Decision Report

Application for Works Approval

Works Approval Number W6931/2024/1

Applicant BP Refinery (Kwinana) Pty Ltd

Figure 2: Worst case nighttime noise contour for scenario 2

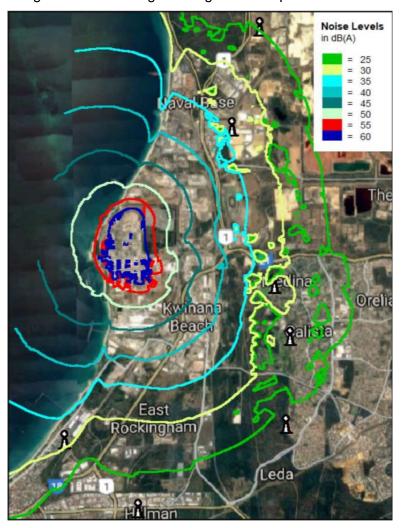
The delegated officer accepted that the operational noise modelling and conclusions were reliable and acceptable. The two modelled operational worst-case scenarios were reasonable and showed the operations should not result in a cumulative increase to noise.

The delegated officer on advice from Environmental Noise Branch's review of noise modelling and conclusions, noted that the noise impact assessment is reliant on the inputs of source sound power levels. Actual noise levels should be monitored and validated during time limited operations with locations within and at the boundary of the premises to verify the noise assessment and compliance with the Noise Regulations.
